# **M28 CORK TO RINGASKIDDY PROJECT**

**REPORT OF TRAFFIC AND TRANSPORTATION CONSULTANT**

**[ISSUE 01, MAY 2018]**

The author of this report is Paul Bergin, B.E., C.Eng. The author was appointed by An Bord Pleanála to advise on traffic and transportation issues and in this regard to:

Figure 4.1: Alternative Corridor Options

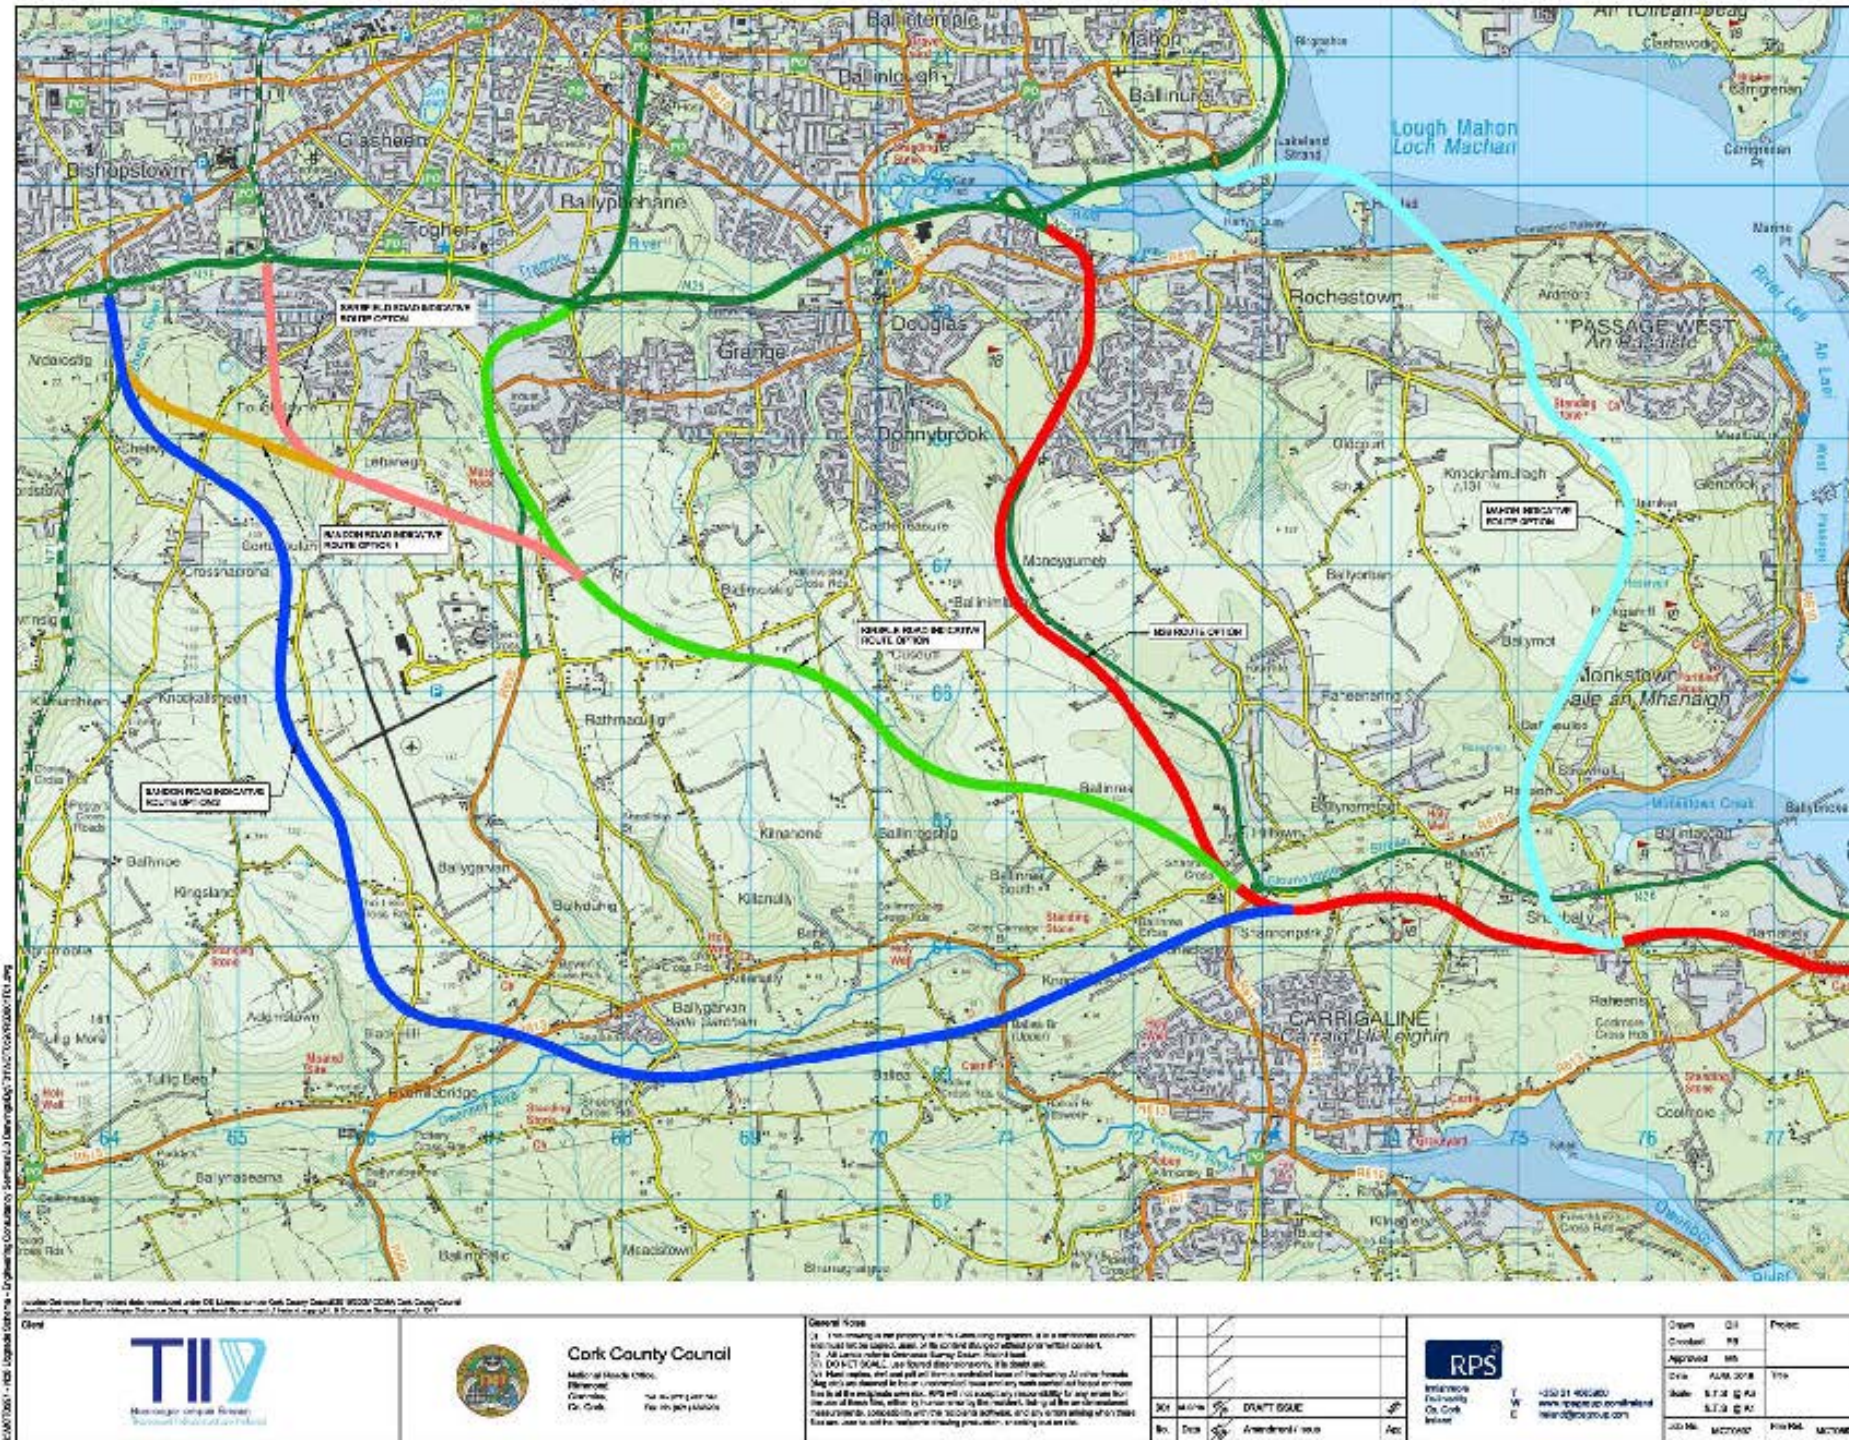
Options (ii), (iii), (iv) and (v) provide the desirable outcome of rerouting the Ten-T corridor away from the residential areas at the northern end of the existing N28 corridor.

The key economic objectives of the Scheme are to serve and support the development of the Port facilities and the economic development of strategically zoned lands at Ringaskiddy. While both of the western options, i.e. Options (ii) and (iii), would provide a motorway standard road between Ringaskiddy and the N40, the existing N28 would remain the most direct route to and from the N40 and Dunkettle Interchange. As a result, for both of the western options, approximately 50% of traffic generated by the Port, by strategically zoned lands and in Carrigaline would continue to use the existing N28. The western options would thus only partially achieve the key economic objectives of the Scheme. In contrast, the M28 Route Option would be the most direct route from Ringaskiddy and Carrigaline to the N40 and would attract most of the traffic generated in these areas.

The M28 Route Option would remove all strategic traffic from the existing N28, thereby increasing the scope for inclusion of pedestrian and cyclist facilities on the existing N28 route. This scope would not be available for a scheme based on either of the western options, which would see continued high levels of traffic on the existing N28 and thus leaving it an unsafe environment for vulnerable road users.

The M28 Route Option would remove all strategic traffic from the existing N28, thereby increasing the scope for inclusion of pedestrian and cyclist facilities on the existing N28 route. This scope would not be available for a scheme based on either of the western options

Figure 6.3.1 Cross-sections through the Scheme at Newlyn Vale.

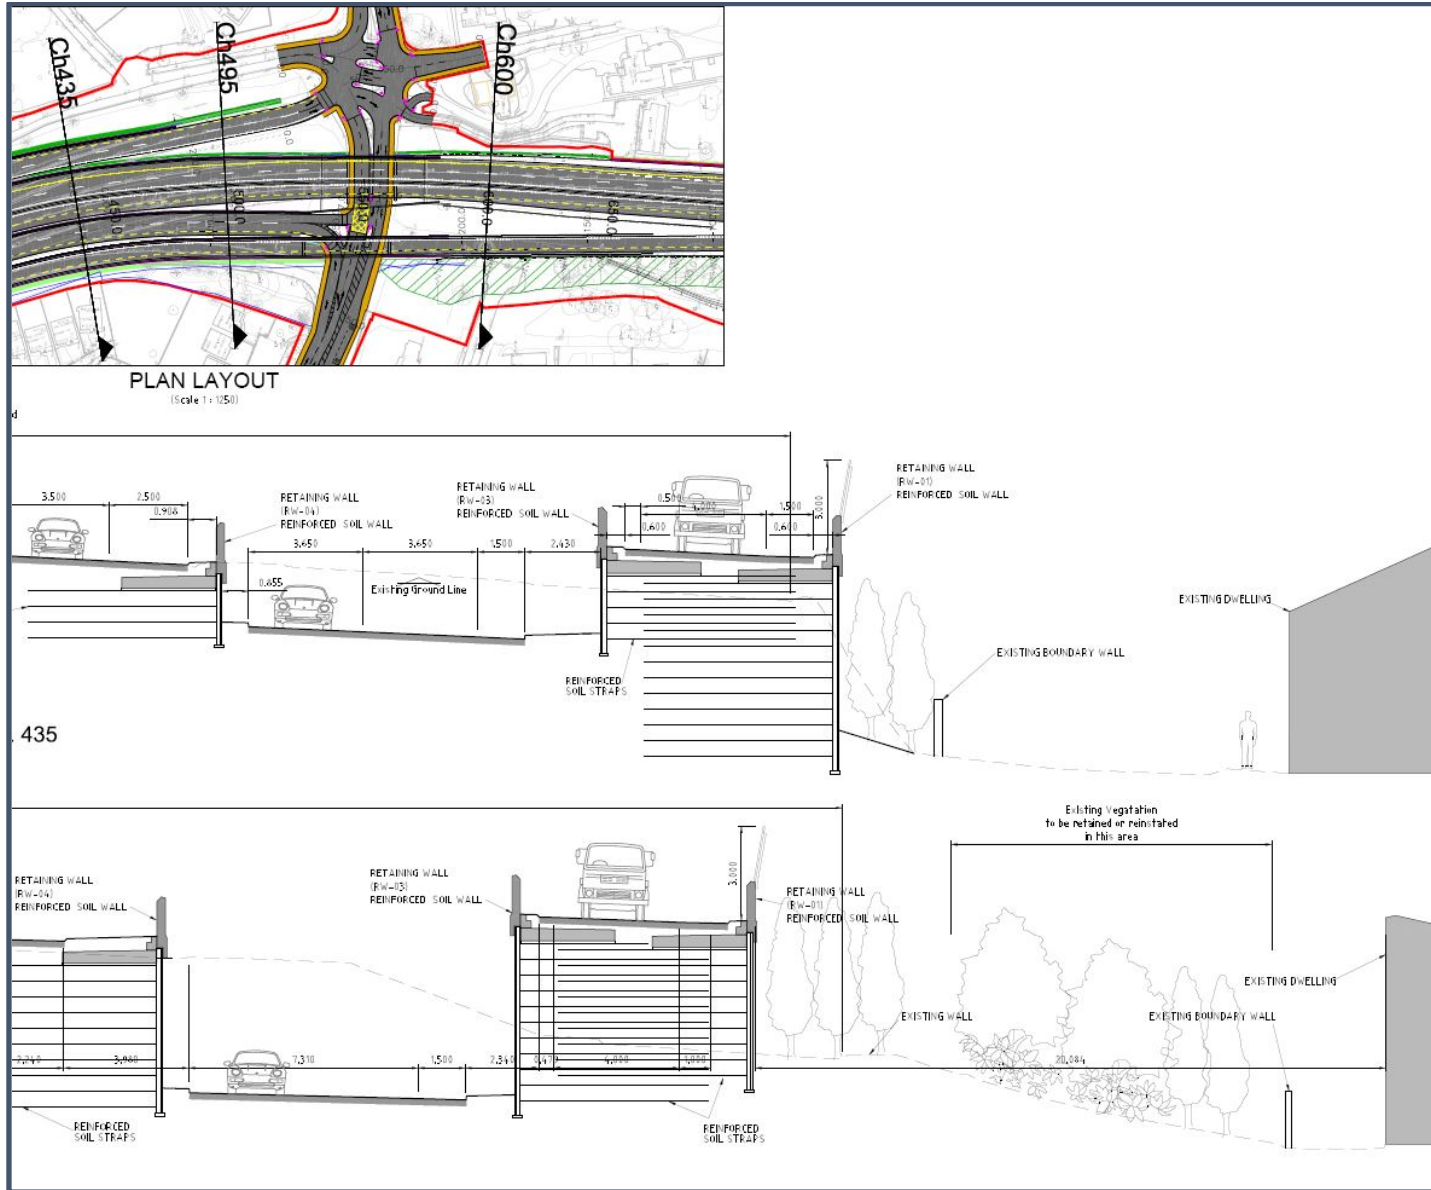
The Diverge Lane is closer to and higher than the existing N28 on either side of the Rochestown Road, at locations where it adjoins the Rochestown Rise, Newlyn Vale and Wainsfort residential estates. The EIS contains a series of drawings showing cross-sections at various locations through the Scheme. Figure 6.3.1 provides an extract from one of these drawings, Drawing No CS0102, which contains two cross-sections through the Scheme as it adjoins Newlyn Vale.

During the Oral Hearing, the author suggested that the Applicant give consideration to an alternative arrangement whereby the Diverge Lane is introduced as an auxiliary lane, thus eliminating the need for eastbound M28 traffic to cross into the fast lane. The Applicant undertook to do so and subsequently presented a revised proposal for the Diverge Lane, shown on Drg. No. SK5067 which is included in Annex I to this report. This revised proposal uses an auxiliary lane to introduce the as suggested by the author. The revision is achieved within the lands being acquired and with minimal impact. It is recommended that this alternative be incorporated into the Scheme.

Note that this revised proposal does not affect the line and level of the Diverge Lane where it adjoins Newlyn Vale.
